SUNDRY NOTICES AND REPORTS ON WELLS

Mescalero Ridge Unit "28" #32

Devon Proposes To Permanitly Plug And Abandon As Follows:

DEVON ENERGY CORPORATION WELLBORE SCHEMATIC

DEVON ENERGY CORPORATION WELLBORE SCHEMATIC

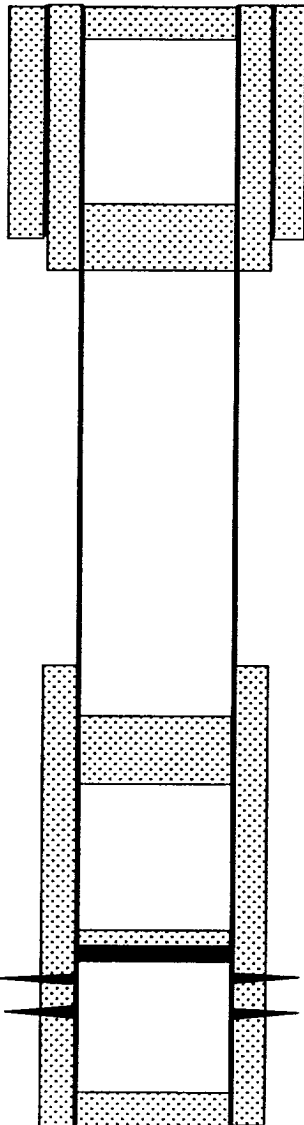
PERF & SQUEEZE (IF POSSIBLE) CEMENT PLUG
@ 1800' - 1900'

SEE ATTACHED FOR
CONDITIONS OF APPROVAL
